# SLIM CHICKENS SITE PLAN

PARKER AND PINE FILING NO. 1, LOT 3

Line denotes acknowledged Changes made by applicant on this Review 03 dated 4.9.21  
 Blue cloud denotes new comment on this Review 03 dated 4.9.21

### TOWN OF PARKER PLAN REVIEW

**01 PHOTOMETRIC PLAN**  
SCALE: N.T.S.

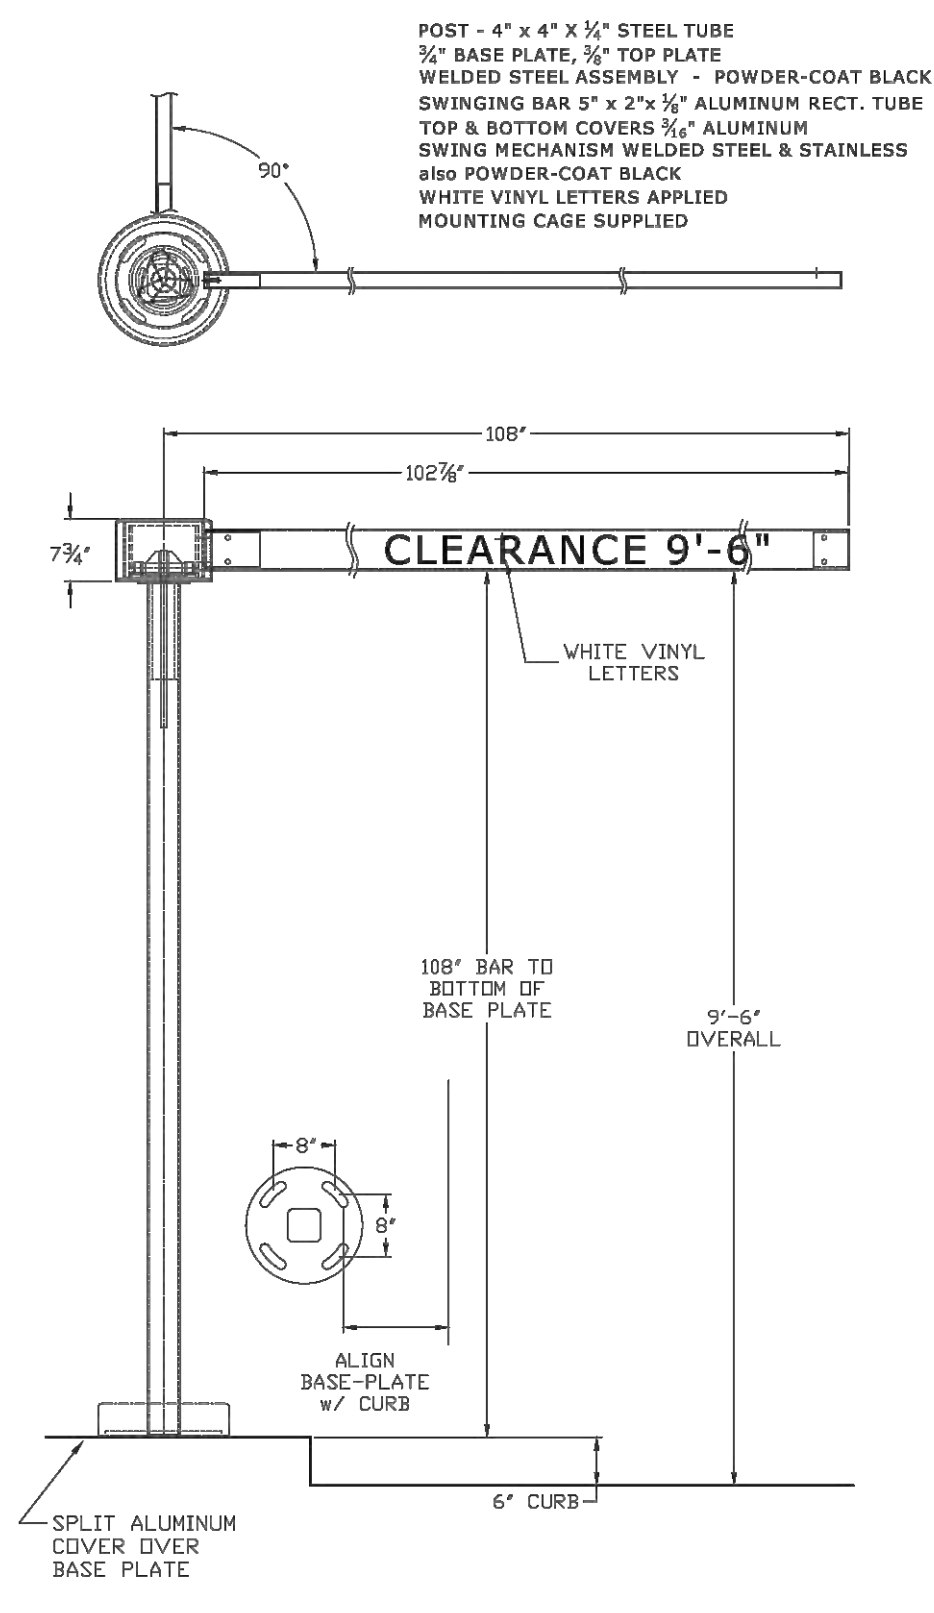
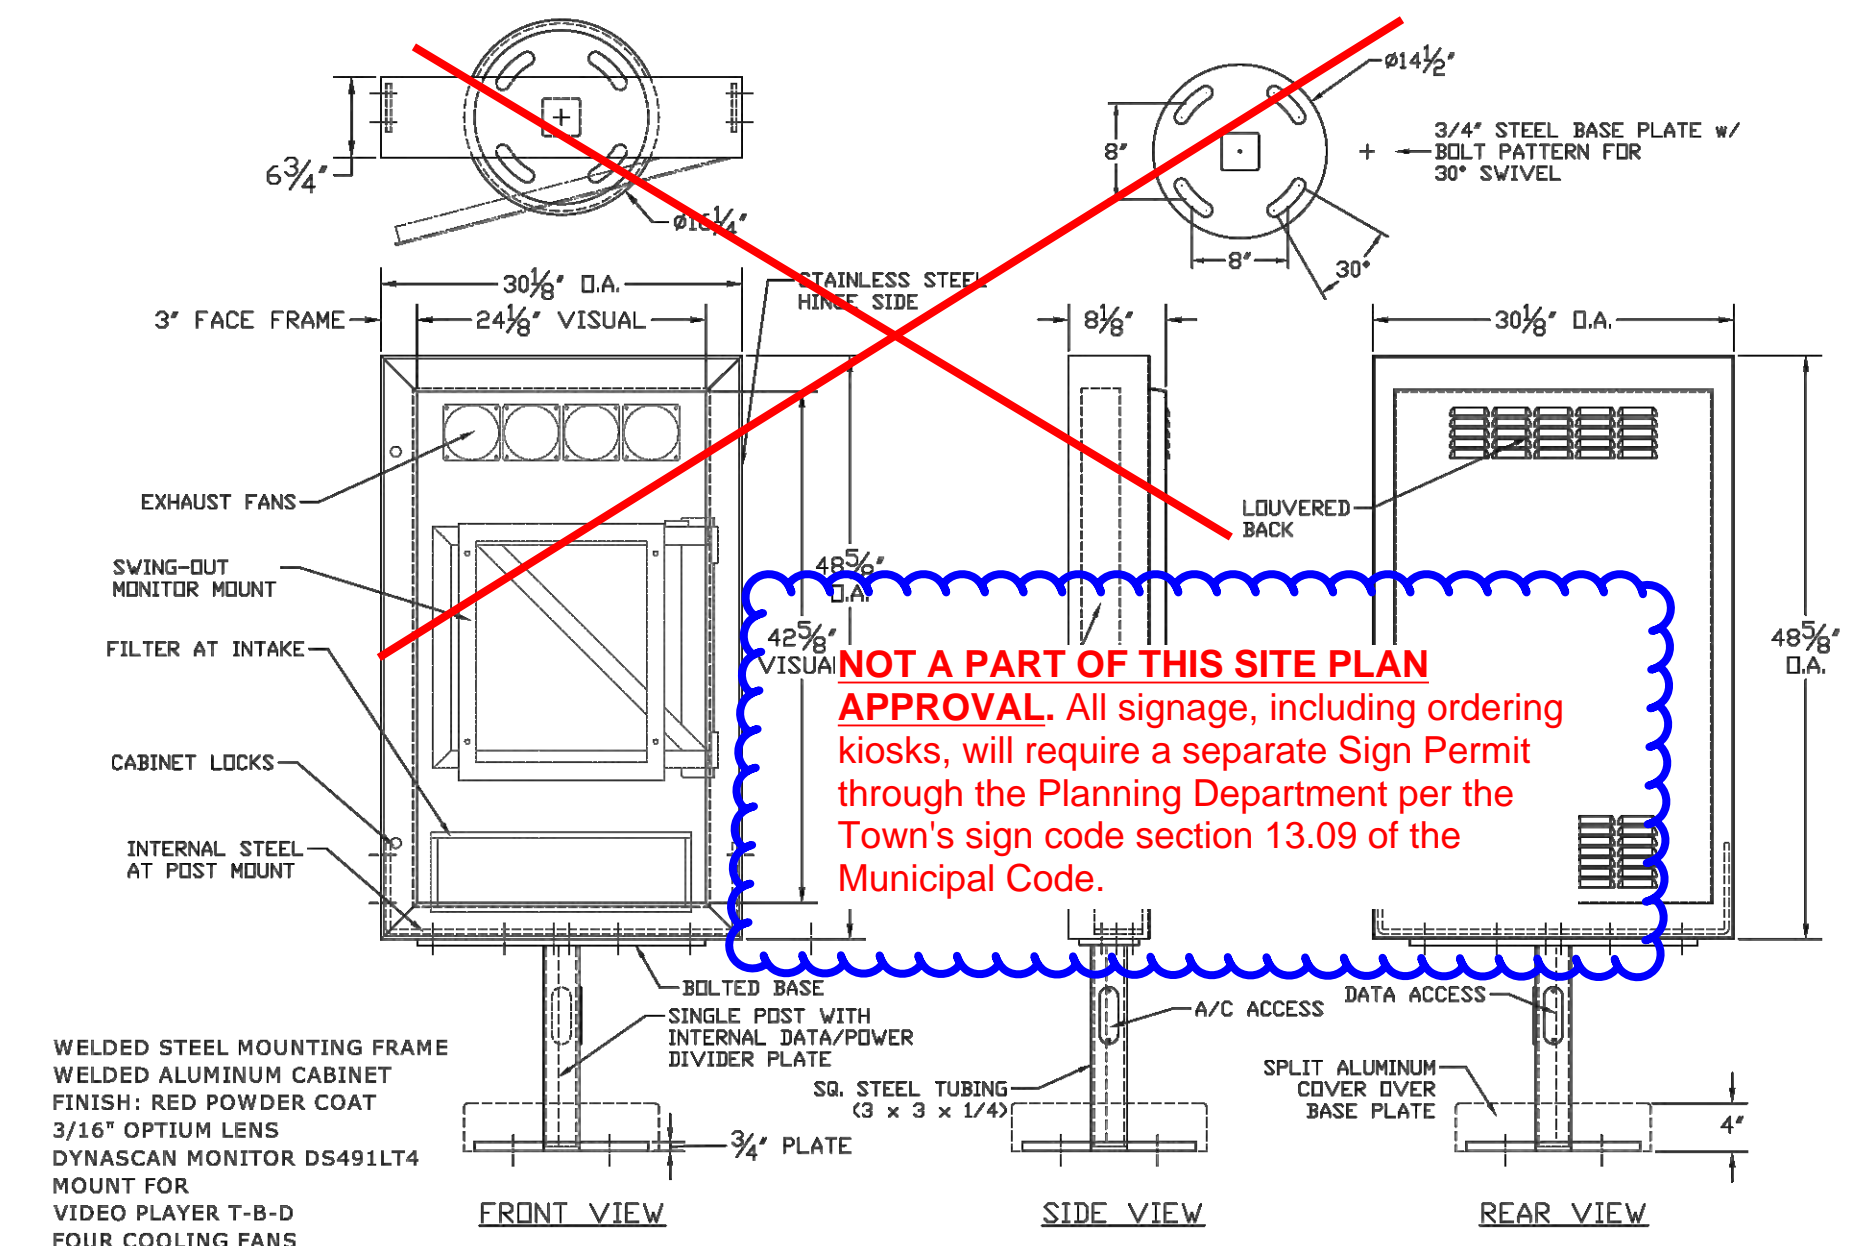
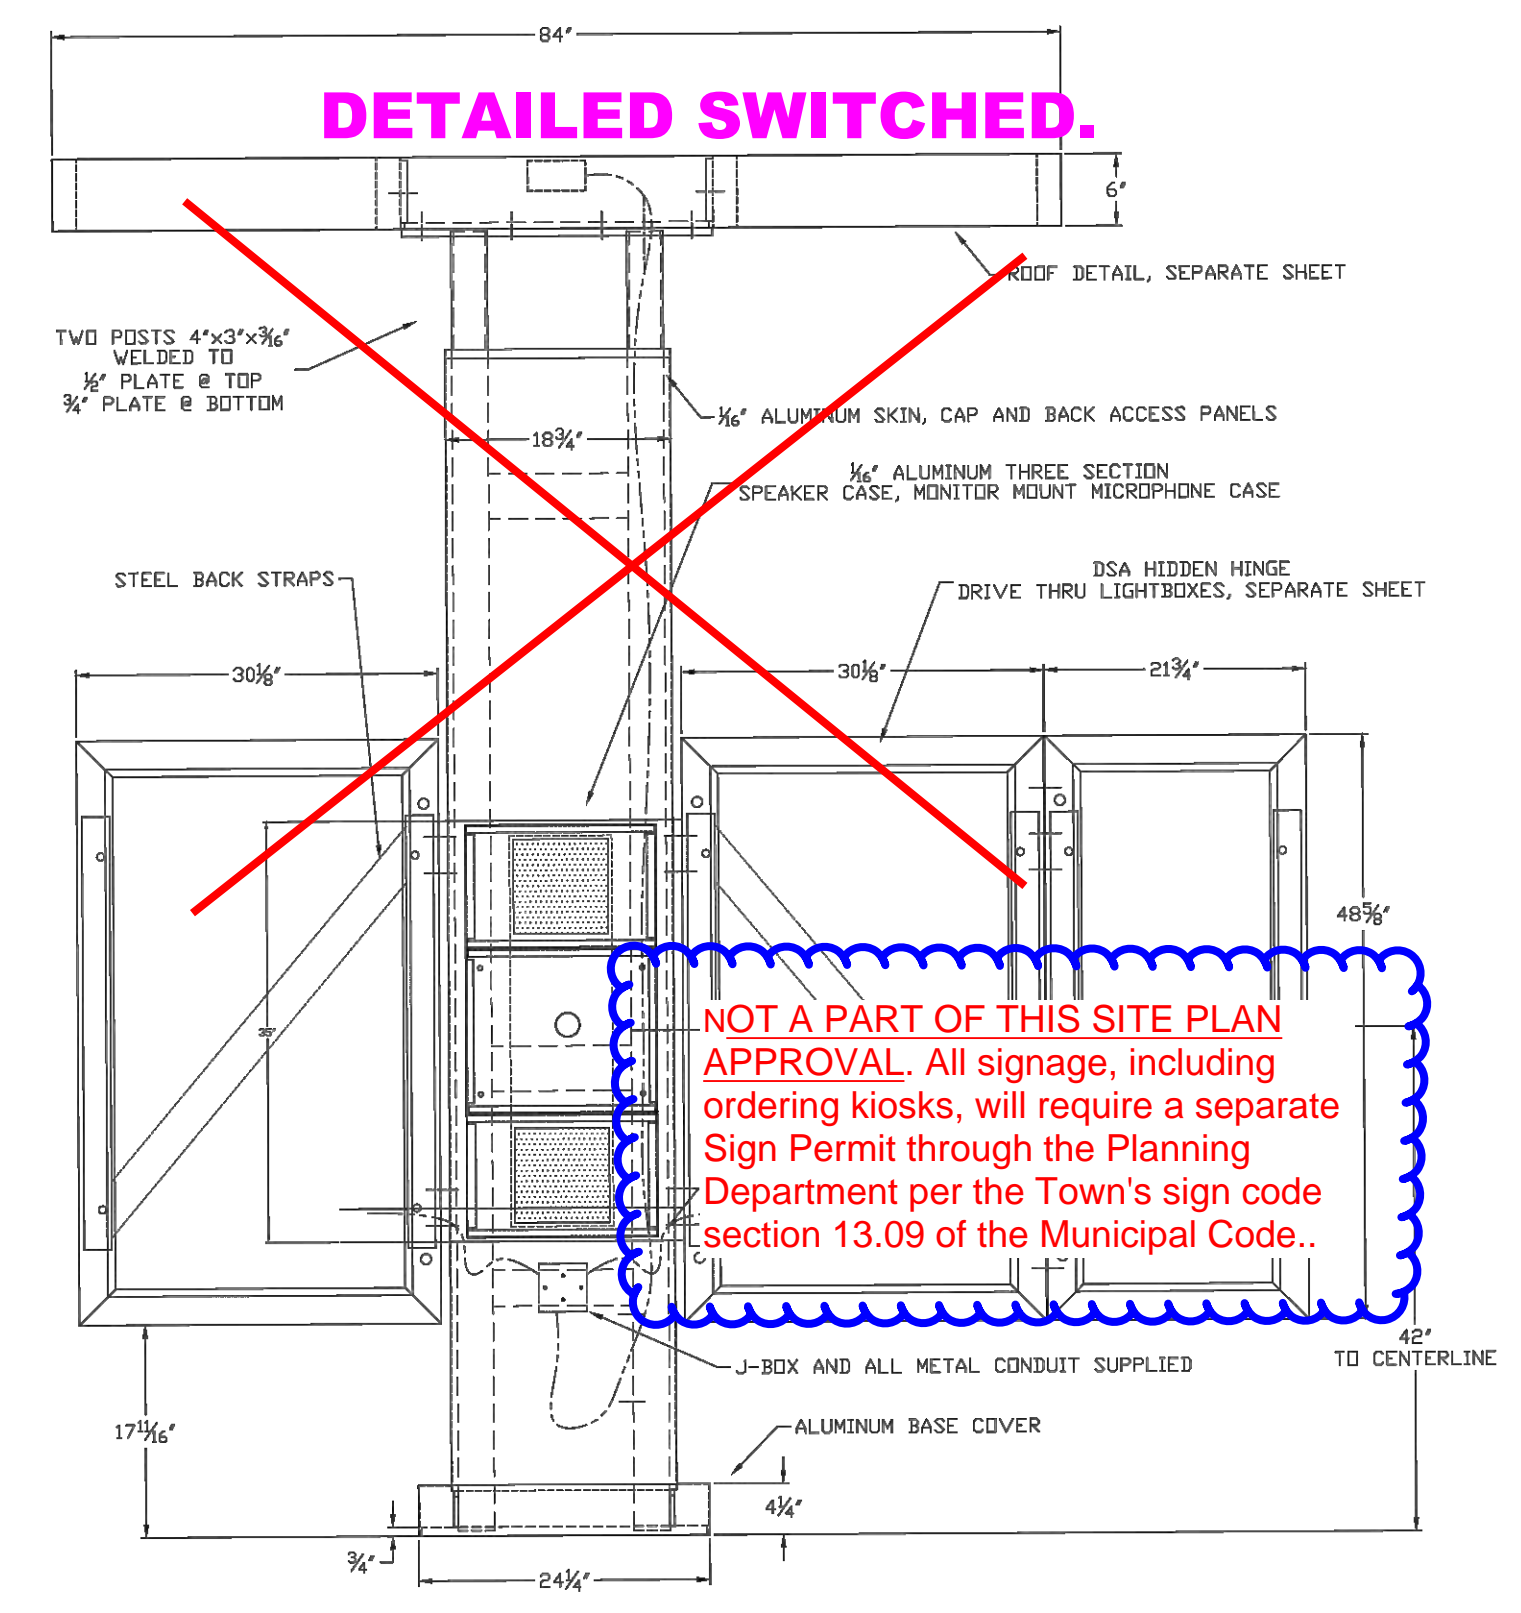
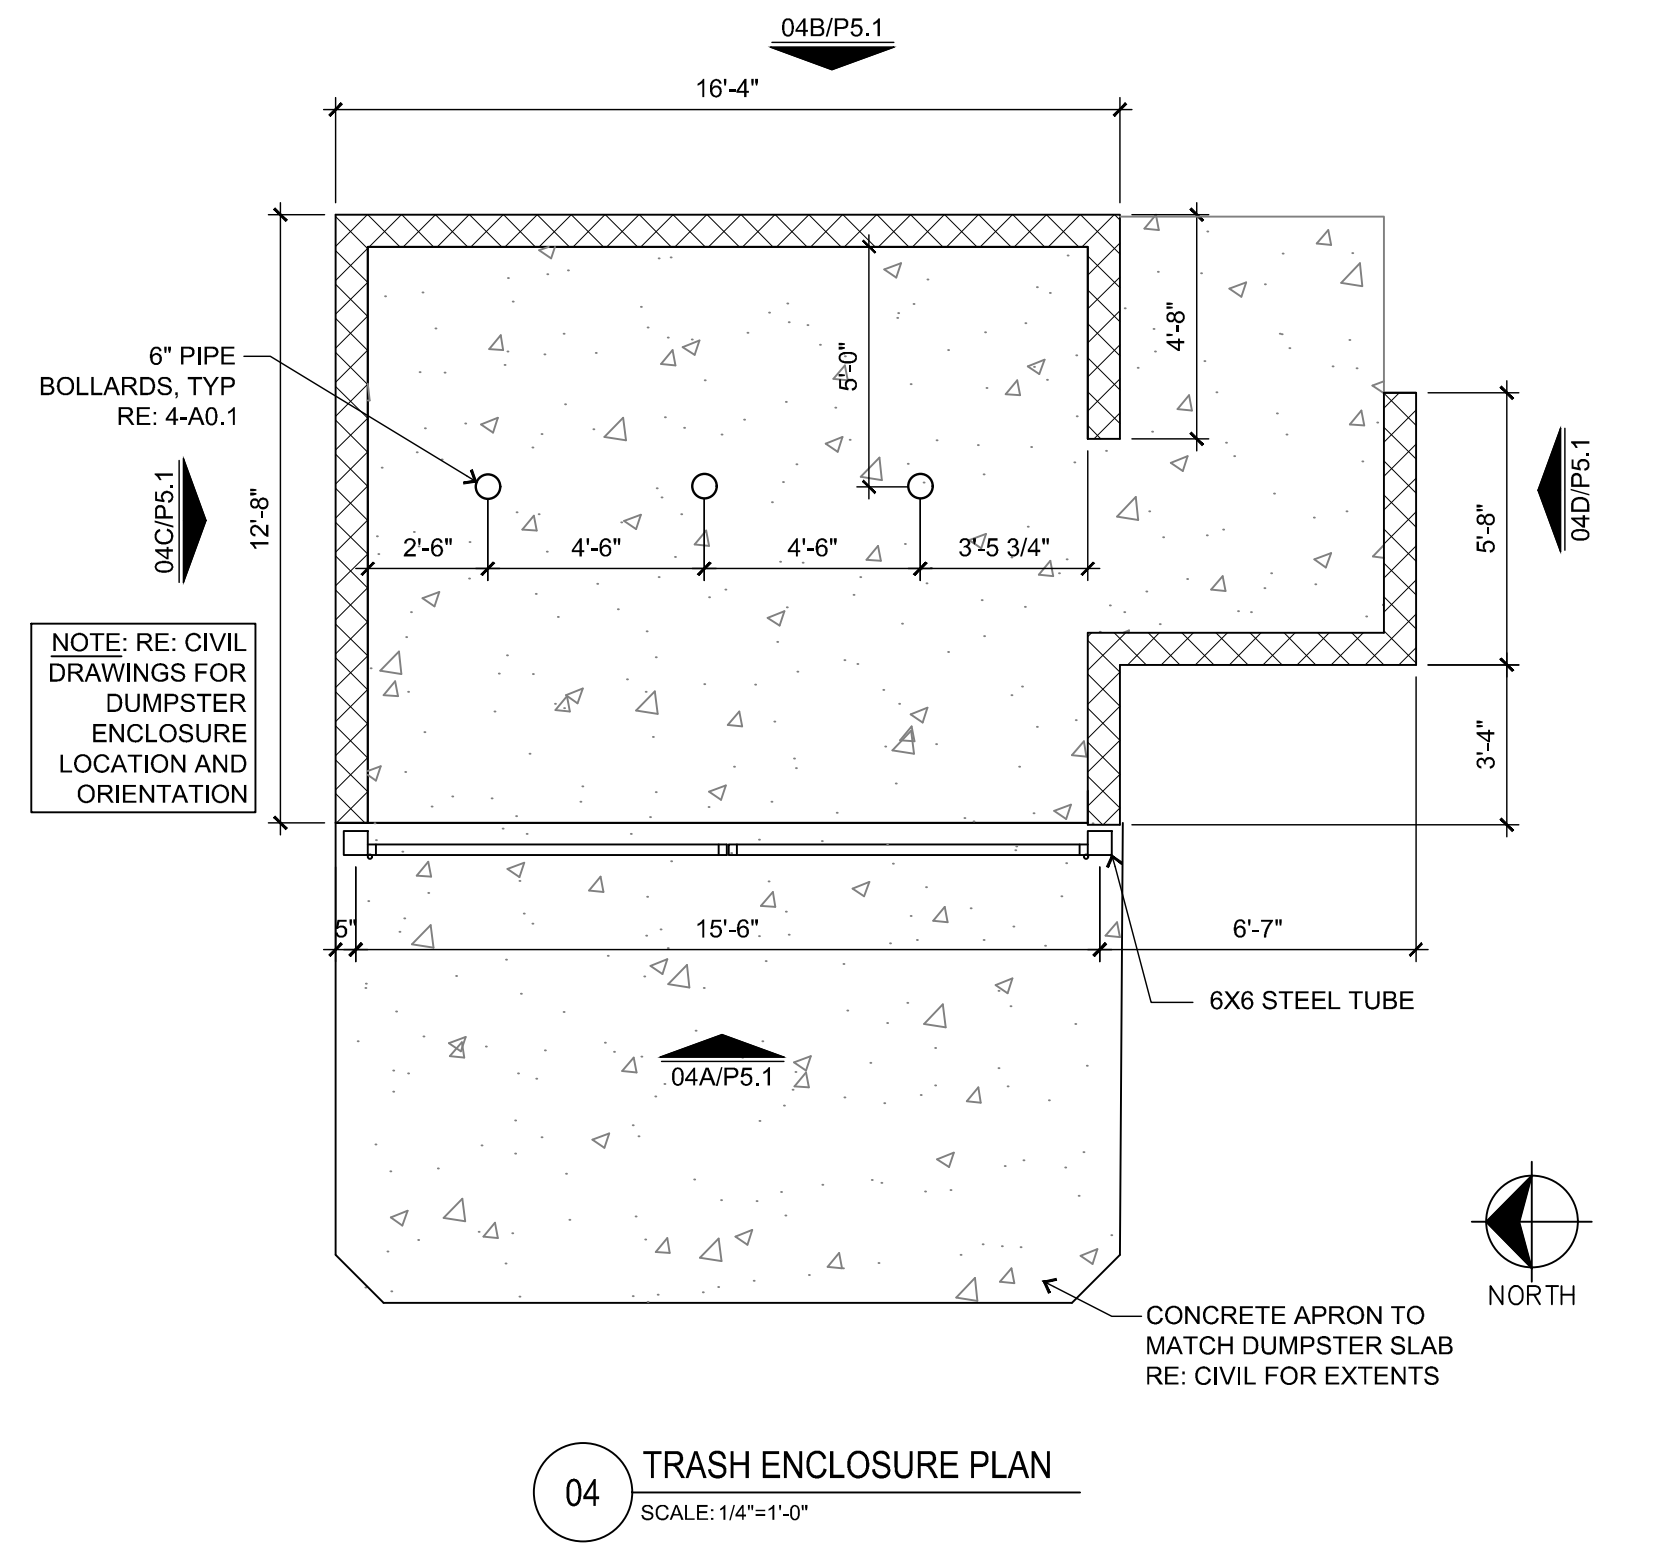
Please note on plan the lighting will not exceed the height of building.

**LIGHTS ADDED TO THIS SHEET**

**SITE PLAN**  
**SLIM CHICKENS**  
SWC OF S PARKER ROAD AND E PINE LANE, PARKER, CO 80134  
**BUILDING ELEVATIONS**

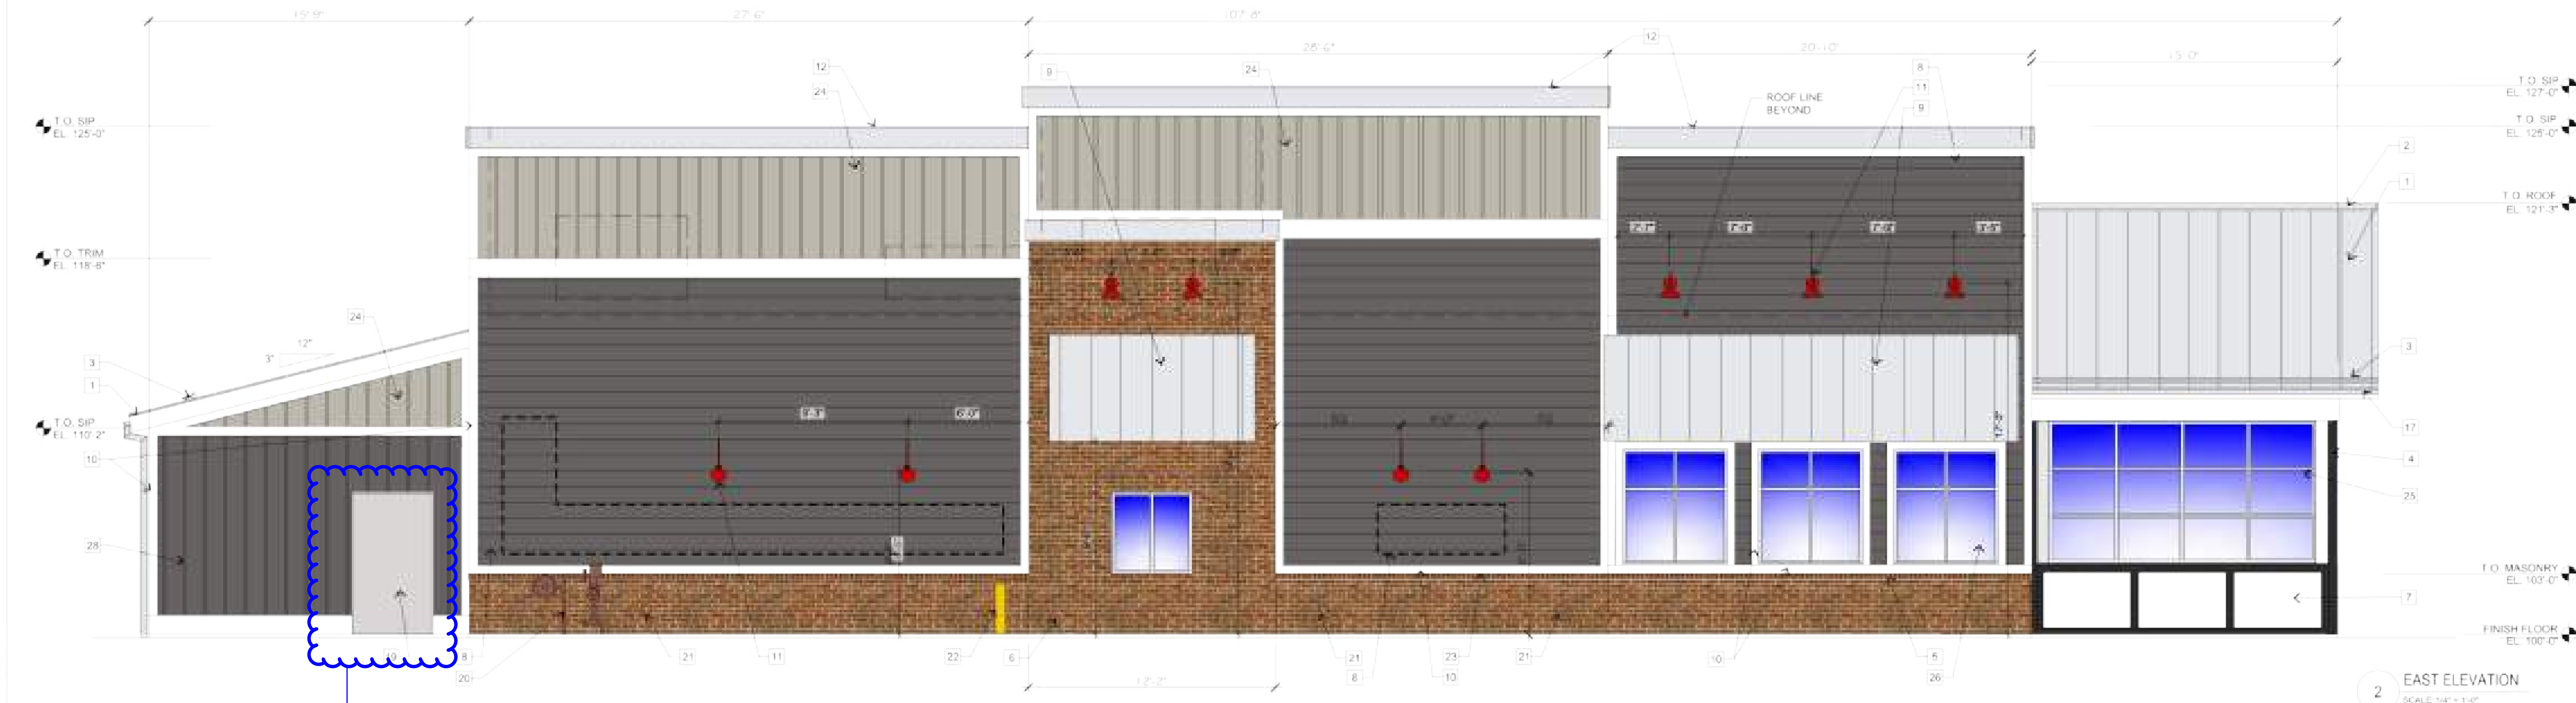
Door color to be dark like others?
